Our File: PB 3965 0101

Project Scope Revision for  
Villalta Gold Project

Klohn Leonoff Ltd. on behalf of Canamin Resources Ltd. of North Vancouver intends to undertake a feasibility study of the Villalta Gold Project. A prospectus was originally filed with the Mine Development Steering Committee for this project on June 2, 1986. A compendium of comments compiled by the Steering Committee in response to the prospectus was issued on August 15, 1986.

<b>PROJECT</b> VILLALTA HEAP LEACH GOLD	
	<b>TITLE</b> LOCATION AND PROJECT LAYOUT	
<b>CLIENT:</b> CANAMIN RESOURCES LTD.	<b>DATE OF ISSUE</b> March 15/88 APPROVED T. Bure	<b>PROJECT No.</b> PB 3965 01
	<b>DWG. No.</b> B-1001	<b>REV.</b>

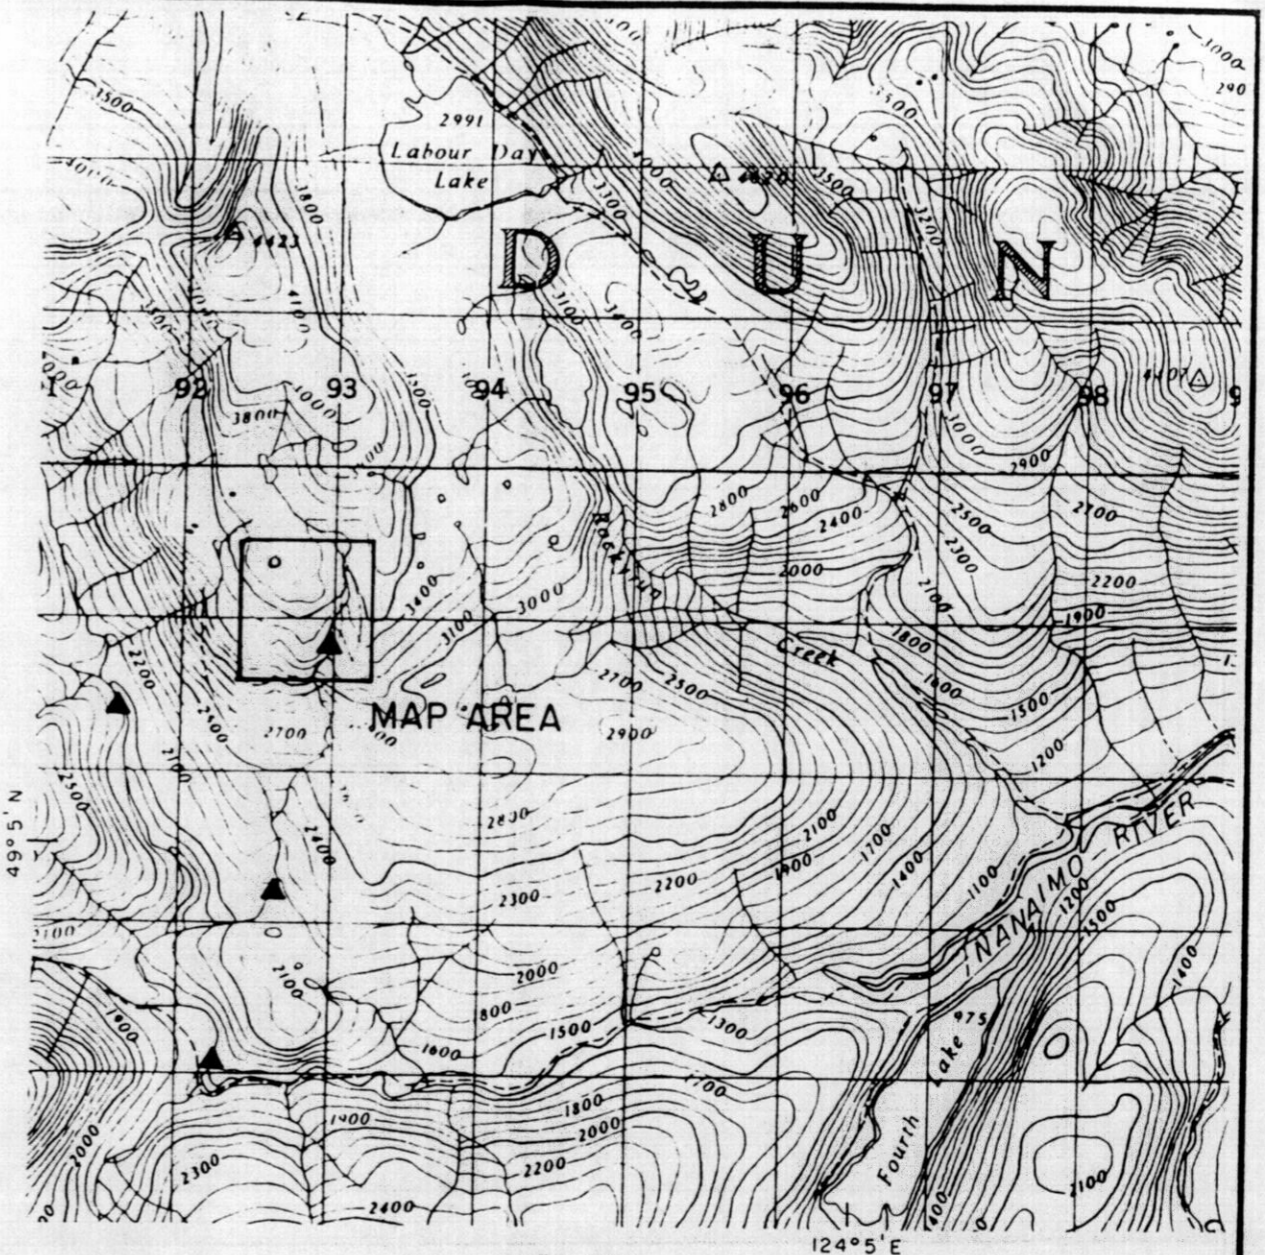
appropriate authorities at this time. A brief description of the project follows. Previous location drawings were provided in the original prospectus and have not been reproduced here. A drawing with detailed topography and a proposed project layout is included here as Drawing B-1001.

The leach pad is expected to cover an area of approximately 40 m square. The pad will be constructed on a relatively flat area a short distance from the pit. The relative locations of the pit and leach pad are shown on Drawing B-1001. The foundation will be shaped using glacial till or other borrow material. A liner system using a combination of glacial till and geomembranes will be designed to collect pregnant solutions and prevent leakage to the environment. The project will be designed so

Baseline water quality testing is proposed for four surface sites upstream and downstream of the project area. Two will be located on the headwaters of the Nanaimo River. Two will be located on an unnamed tributary creek southeast of the site. The proposed sampling locations will be located as shown on Drawing B-1001.
